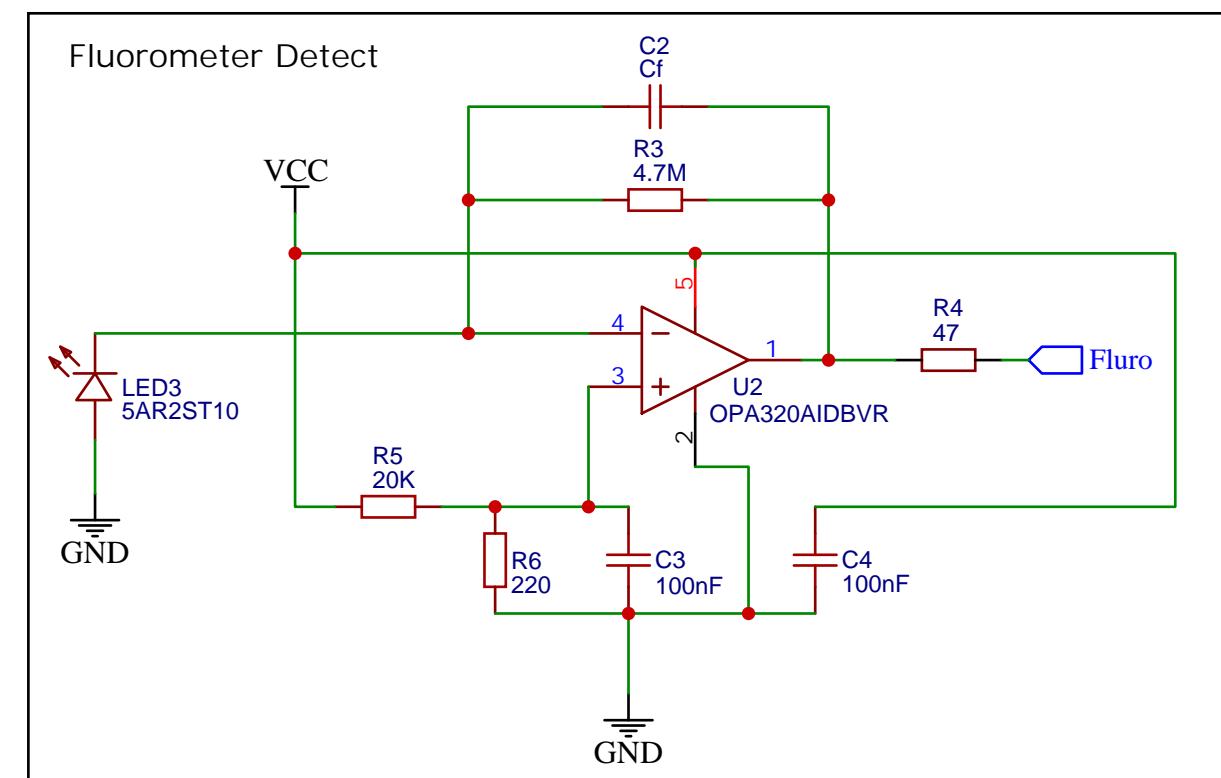
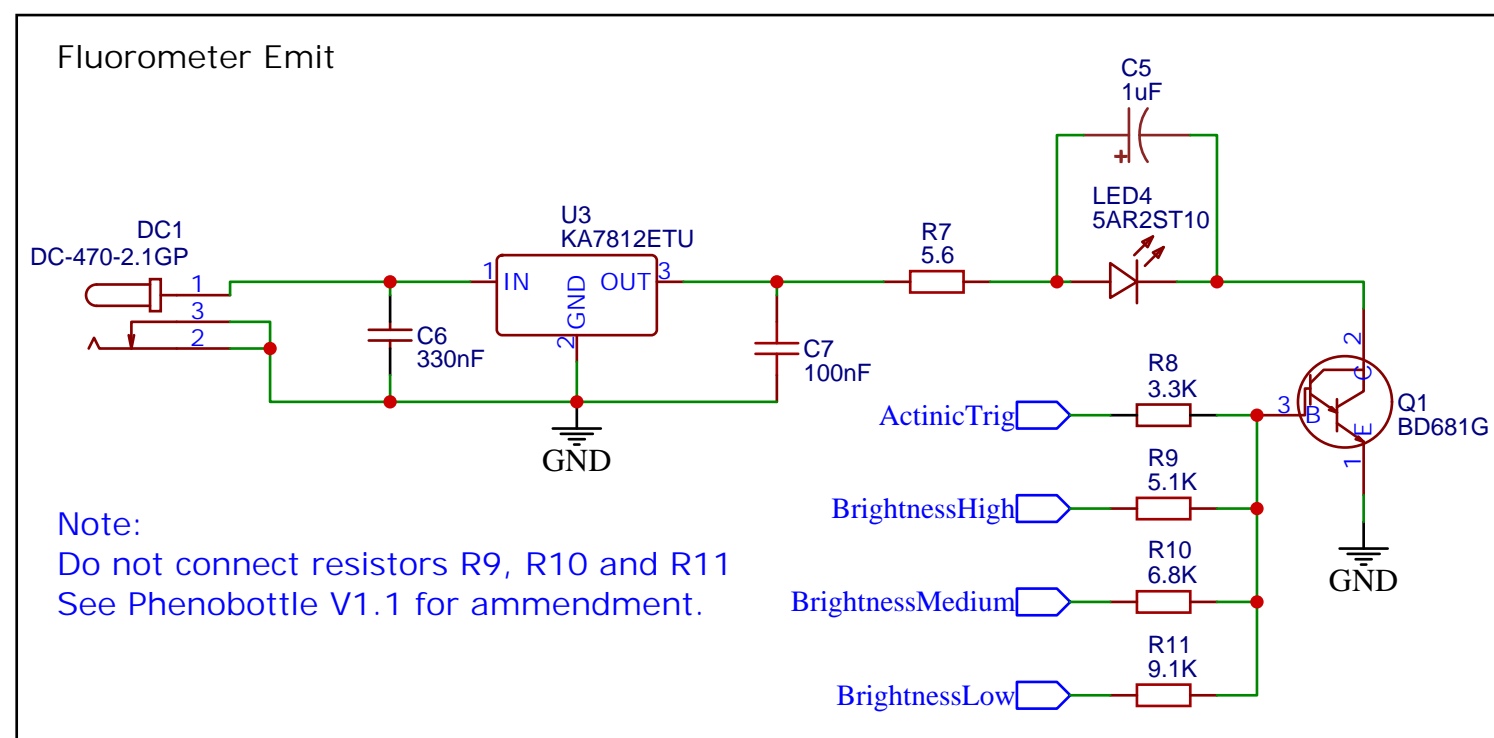
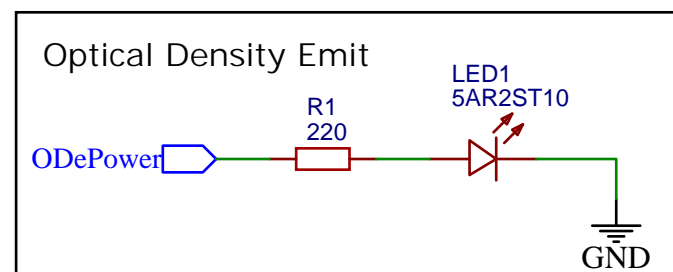
Note:  
Optical Density Detect circuit may provide voltages greater than 3.3V,  
which may damage the Teensy 3.6 analog to digital converter.  
See Phenobottle V1.1 for an amendment to this sensor.

Note:  
Do not connect resistors R9, R10 and R11  
See Phenobottle V1.1 for ammendment.
